PROJECT : 1X800MW TANGEDCO NORTH CHENNAI TPP **DATE:** - 27.12.2017
PACKAGE : AIR CONDITIONING SYSTEM
TENDER ENQUIRY NO.: PE/PG/NC3/E-5784/2017 dtd. 28.11.2017

Corrigendum-02

1x800 MW NORTH CHENNAI TPS
ANNEXURE – A: CHANGES TO THE TECHNICAL SPECIFICATION

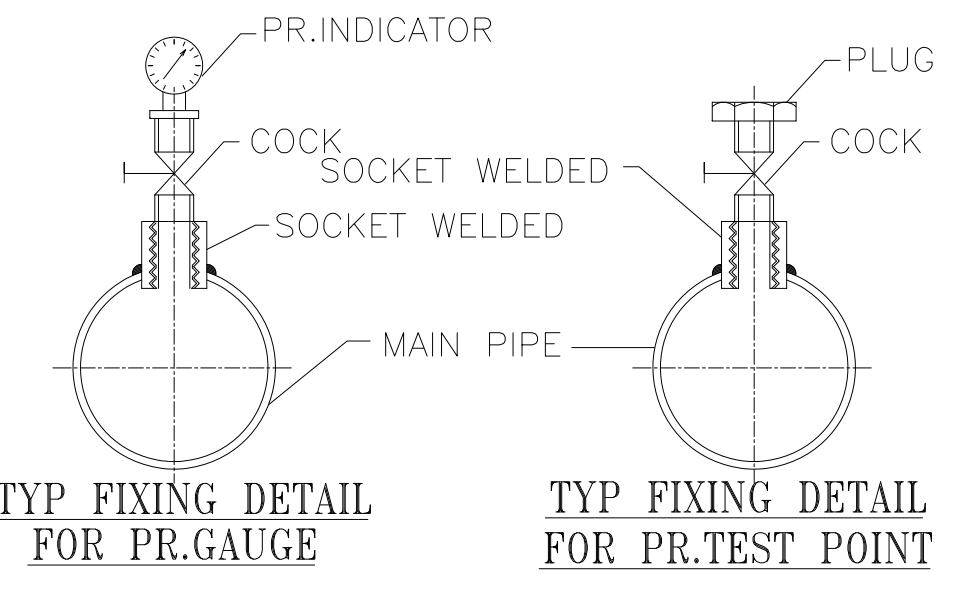
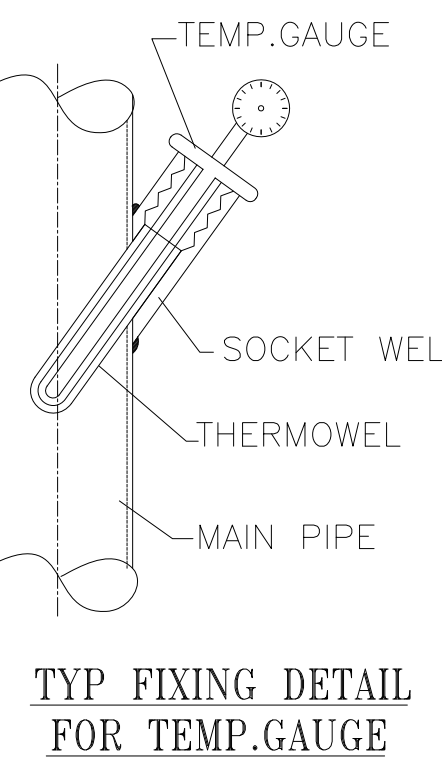
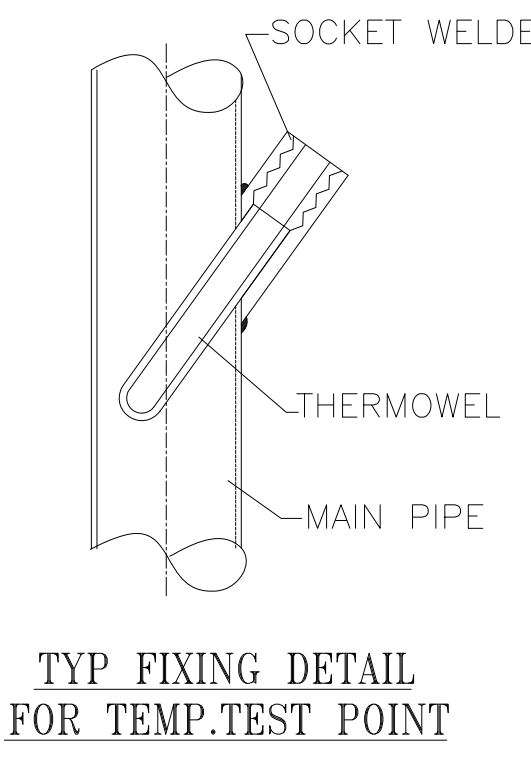
Package AC supplied in Service Building to be provided for facilitating remote selection of standby units. Apparatus dew point of package unit shall be min. 52 deg. F or as per system requirement. Package AC to be selected accordingly.
	P&ID FOR AC System		720 OF 721		Instruments indicated in the P&ID is indicative. Any additional instrument required for the completeness of the system shall be in bidder scope. Further, bidder to follow clause no. 1.12, 1.13, 1.14 for Instrument Redundancy.
	P&ID FOR AC System		720 OF 721		Revised P&ID for Air Conditioning System is enclosed.
TECHNICAL SPECIFICATION SUGGESTIVE PRICE FORMAT, REV. 01				1. Annexure – I: S. No. C1(b): 20TR AC quantity shall be 32 Nos 2. Annexure – I: S. No. C2: Fibreglass reinforced plastic (FRP) construction cooling towers of adequate capacity, complete with fan, motor, FRP basin, nozzles, make-up water & quick fill water connection, drains, piping, valves, strainers, ladder & all accessories as specified (Minimum 400 TR) 3. Annexure – I: S. No. E1, E1a (15 TR net capacity- 2 Nos), E1b (20 TR net capacity- 2 Nos) - Air Cooled Package AC 4. Annexure – I: S. No. E3, E3a (20 TR net capacity- 2 Nos), E3b (15 TR net capacity- 2 Nos) – Water Cooled Precision AC	1. Annexure – I: S. No. C1(b): 20TR AC quantity shall be 40 Nos 2. Annexure – I: S. No. C2: Fibreglass reinforced plastic (FRP) construction cooling towers of adequate capacity, complete with fan, motor, FRP basin, nozzles, make-up water & quick fill water connection, drains, piping, valves, strainers, ladder & all accessories as specified (Minimum 650 TR) 3. Annexure – I: S. No. E1, E1a, E1b: Requirement under above clause stands deleted. 4. Annexure – I: S. No. E3, E3a, E3b - Requirement under above clause stands deleted.
